Addendum no. 6. 1999

Re: Crandon Project - Addendum No. 6 to the May 1995 *Crandon Project Tailings Management Area Feasibility Report/Plan of Operation*

**Addendum No. 6 to the May 1995
Crandon Project Tailings Management Area
Feasibility Report/Plan of Operation**

4 TYPICAL HAUL ROAD DETAIL
37 NOT TO SCALE

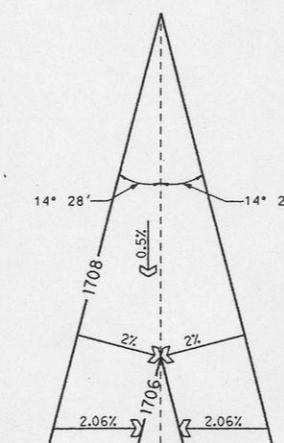
Comment 4: The response to the Department's 4/2/99 Comment 2 in NMC's 6/9/99 letter did not completely address the issue. Please provide additional information regarding traffic routing (both construction and otherwise) from the TMA access road to the area making up Cells 2 and 3 and the soil borrow area following the construction of Cell 1.

Response 4: *The traffic routing to TMA 2 and TMA 3 and the soil borrow area after the construction of TMA 1 is described in the narrative which follows, and the various traffic routes are shown on Figures 6.2-1 and 6.2-2. A typical haul road detail is provided on Drawing No. 37, Detail 4/37.*

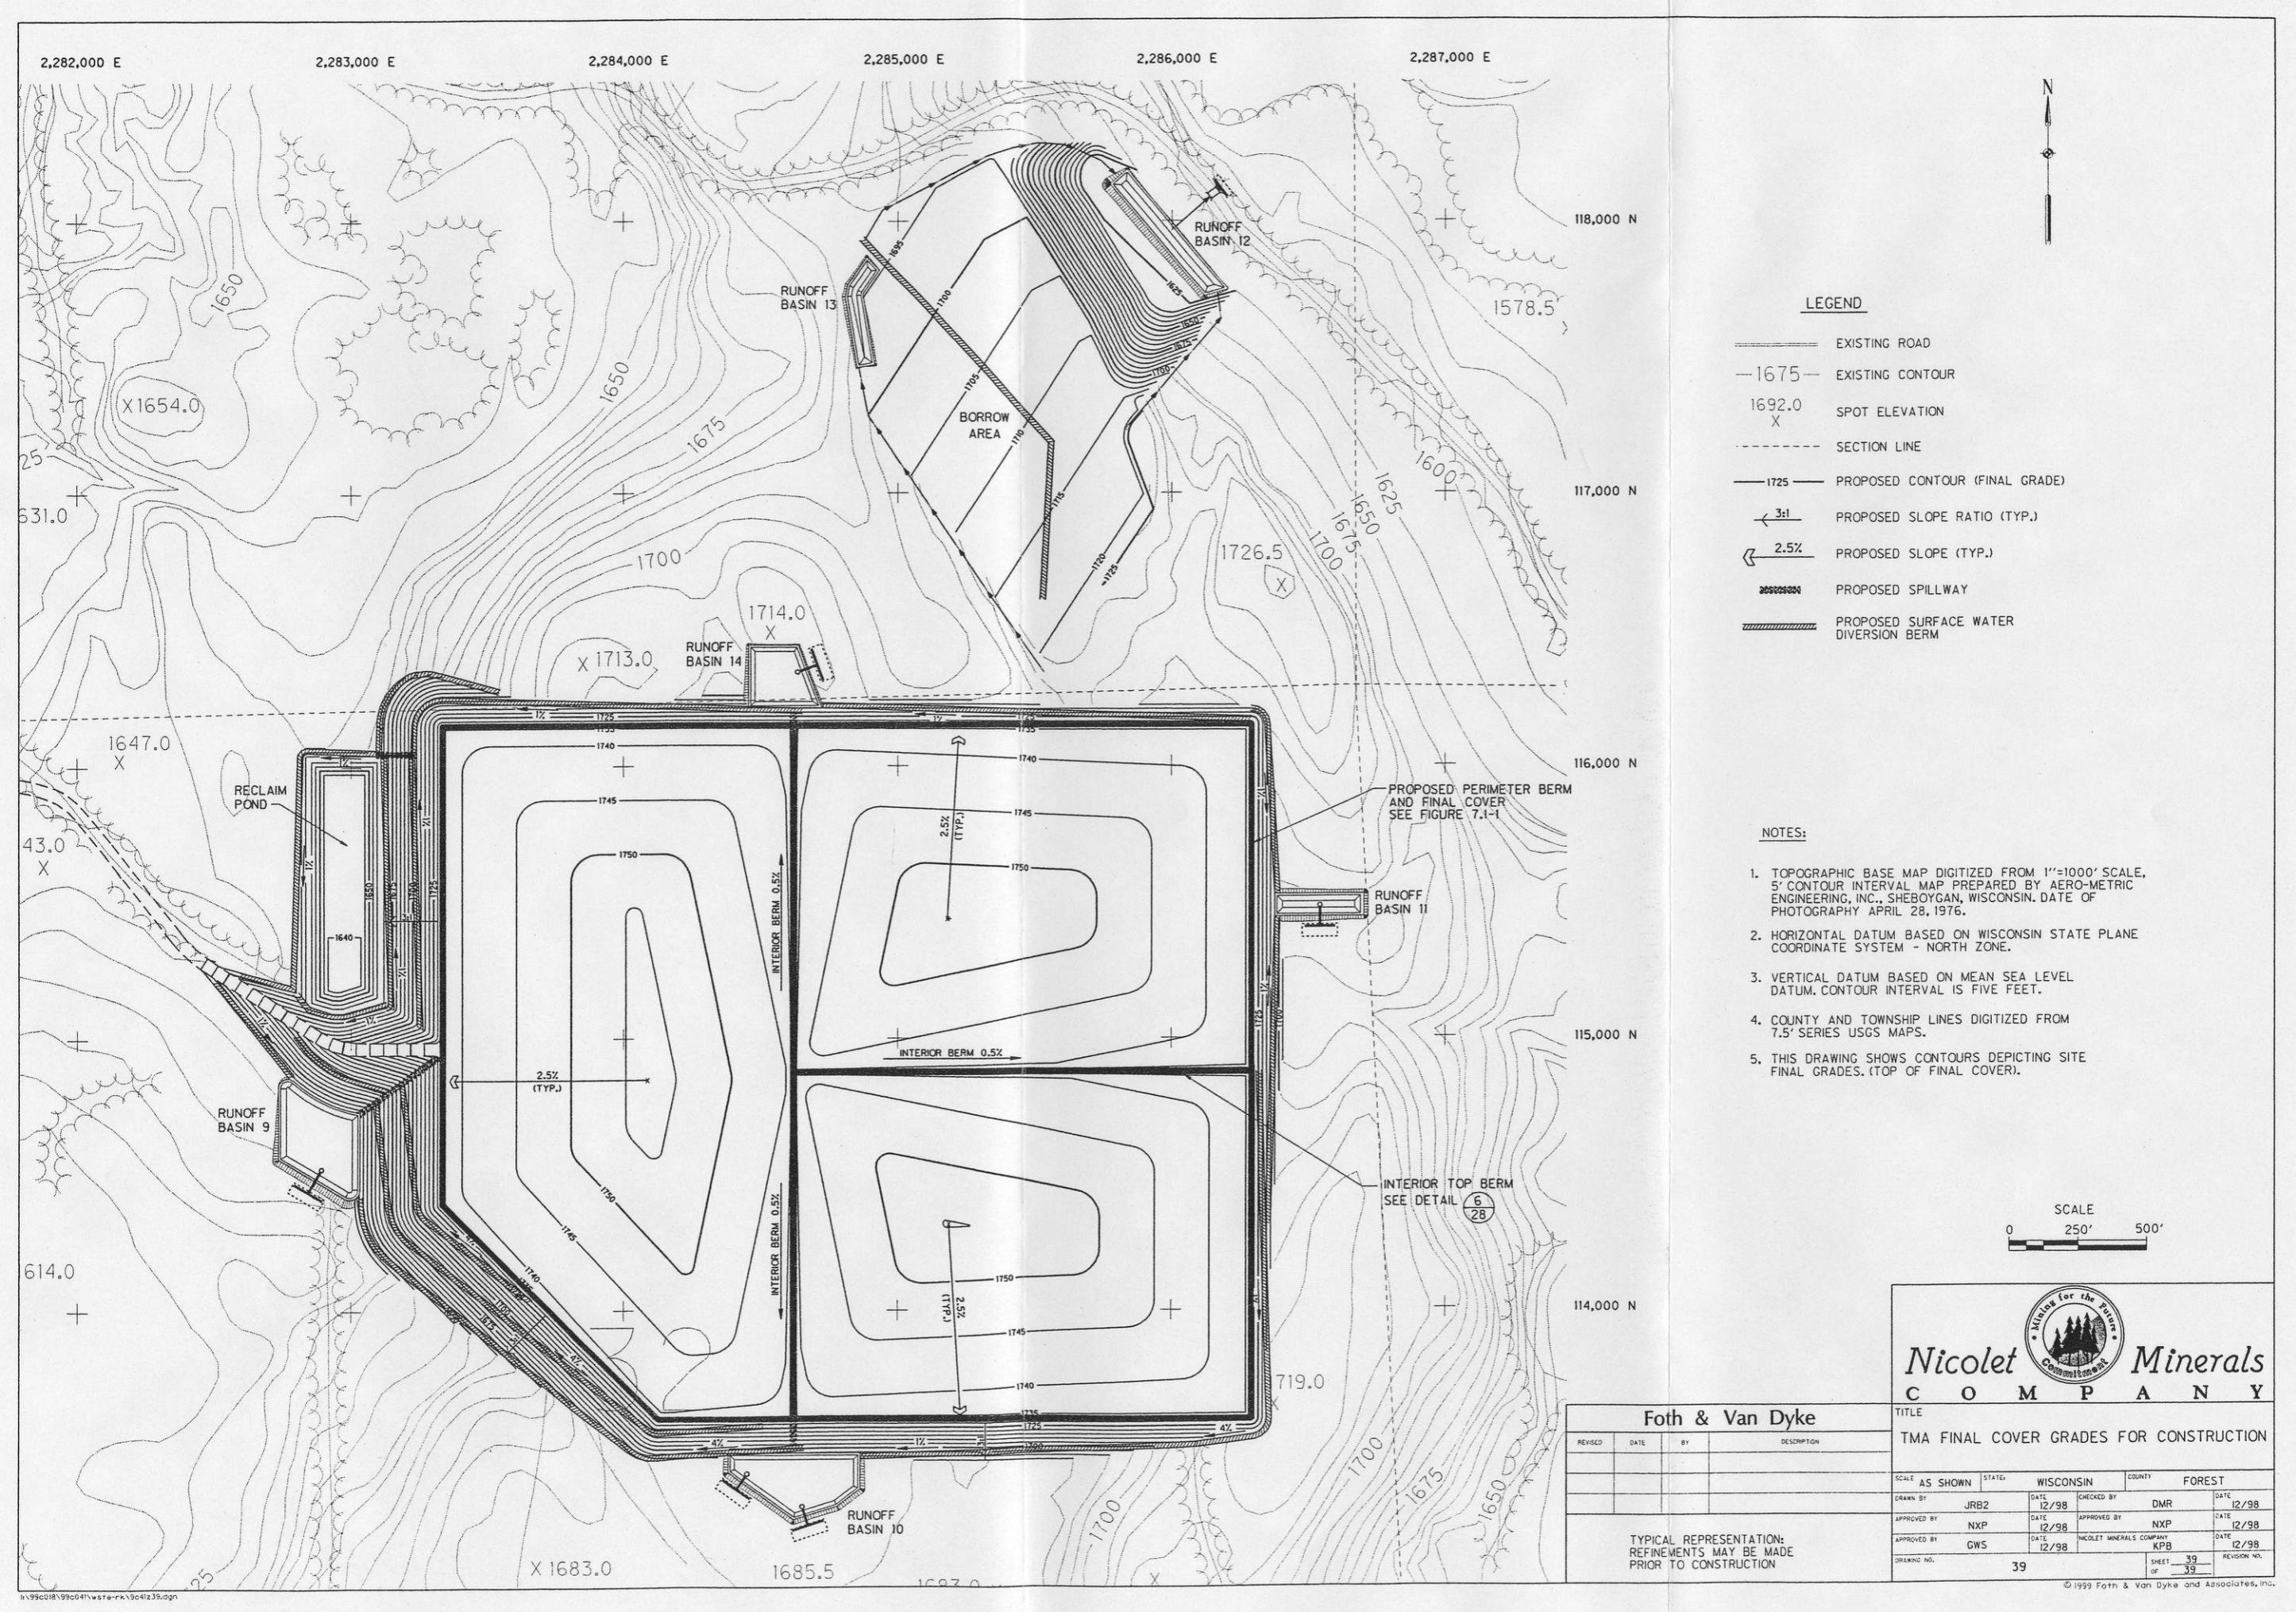
Comment 1: In a letter to the COE dated 9/2/99, NMC's response to COE Comment 20 states that, based on the current design, the TMA final cover minimum slope following settlement will be 1.5%. That statement suggests that based on current information about expected material properties and settlement, the final cover is being designed with a final minimum slope of 1.5%. According to s. NR 182.11(1)(m), Wis. Adm. Code, "the final slopes of a completed waste site shall be no less than 2% . . ." In a letter to the COE dated 10/4/99, NMC revised the response to COE Comment 20 indicating that the minimum final cover slope at the time of cover construction will be 2.5% in order to ensure that the final minimum cover slope will be 2%. Please revise the FR to account for the revised final cover slopes indicated in the letter to COE.

Response 1: *After further review of Chapter NR 182.11(1)(m) Wis. Admin. Code, NMC agrees that the final slopes for each TMA cell will be 2 percent or greater after all primary and secondary settlement has occurred. NMC therefore proposes to initially construct the TMA slopes to a minimum of 2.5 percent, anticipating that the final cover will experience approximately 0.4 percent loss in slope following final cover placement. NMC has redesigned the final grades of the TMA cells to reflect this change in slope, as shown in Drawing No. 39. The change in final cover slope does not affect operation of the TMA facility. Following is a description of how this slope will be formed.*

show that the maximum anticipated change in slope as a result of settlements caused by the weight of the cover system will be approximately 0.4 percent. Therefore, to achieve a final slope of 2 percent after all anticipated consolidation, a constructed slope of 2.4 percent would be required.

As an added conservatism to the project, NMC proposes to construct the TMA final cover slopes (Drawing No. 39) at a minimum of 2.5 percent so that the final slope after all anticipated consolidation will be greater than or equal to 2 percent. The approximate 300,000 cubic yards of material required to attain the steeper slopes of 2.5 percent will be obtained from on-site soil or Type I waste rock. This additional quantity is adequately covered by the contingencies built into the project's soil balance.
